F O R A P P R O V A L

CLIENT Mr & Mrs Molloy	PROJECT High Ridge Pear Tree Lane Shorne Kent DA12 3JU	DRAWN SP	DATE April 2021	SCALE 1:100,200	DWG SIZE A3
WORK STAGE Planning	DRAWING Floor Plans - As Proposed	DRAWING NO. SP-480-P-20-06	REVISION A

Roof Plan
As Proposed

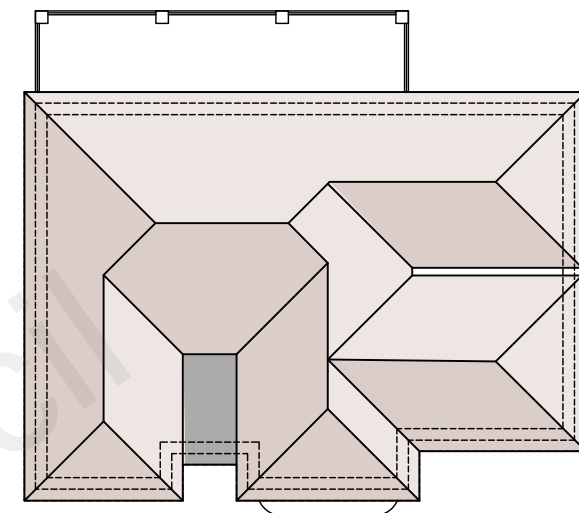
A	13/12/2021	Roof design revised to remove and reduce areas of flat roofing. Lantern removed from two storey extension.
Rev	Date	Comment
Revisions
